# UNITED STATES PATENT AND TRADEMARK OFFICE

APPLICATION NO.	FILING DATE	FIRST NAMED INVENTOR	ATTORNEY DOCKET NO.	CONFIRMATION NO.
10/813,463	03/29/2004	Horst Sipple	ZTP01P13012	4675
24131 7	7590 11/19/2004		EXAMINER	
LERNER AND GREENBERG, PA			SCHULTERBRANDT, KOFI A	
P O BOX 2480 HOLLYWOO	D, FL 33022-2480		ART UNIT	PAPER NUMBER
	,		3632	
		DATE MAILED: 11/19/2004

Application No.	Applicant(s)				
Office Action Summer	10/813,463	SIPPLE, HORST				
/ Office Action Summary	Examiner	Art Unit				
	Kofi A. Schulterbrandt	3632				
The MAILING DATE of this communication app Period for Reply	ears on the cover sheet with the c	correspondence address				
A SHORTENED STATUTORY PERIOD FOR REPLY IS SET TO EXPIRE 3 MONTH(S) FROM THE MAILING DATE OF THIS COMMUNICATION.  - Extensions of time may be available under the provisions of 37 CFR 1.136(a). In no event, however, may a reply be timely filed after SIX (6) MONTHS from the mailing date of this communication.  - If the period for reply specified above is less than thirty (30) days, a reply within the statutory minimum of thirty (30) days will be considered timely.  - If NO period for reply is specified above, the maximum statutory period will ap

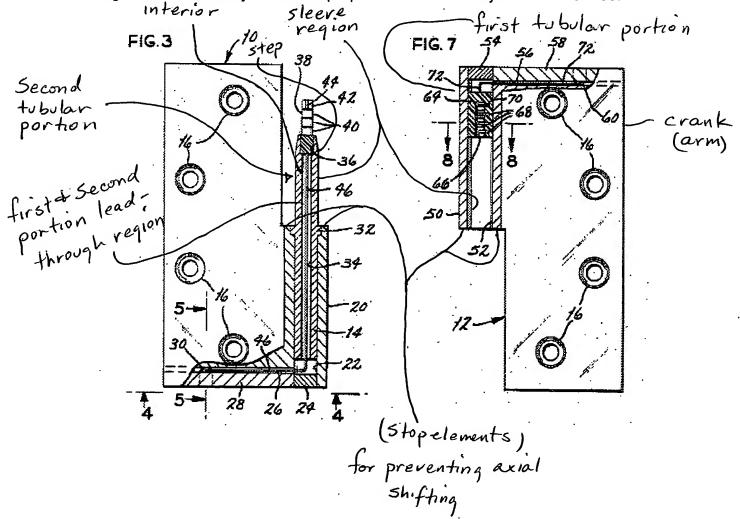
Claims 1-23 are rejected under 35 U.S.C. 102(b) as being anticipated by Peterson (3,838,234). Peterson teaches each feature of the claimed invention as shown below. Regarding claim 1, Peterson teaches a crank form in that the hinge portion (10) projects radially away from and perpendicular to the axis of turning of the hinge in the same way a crank is perpendicular to the object to be cranked.
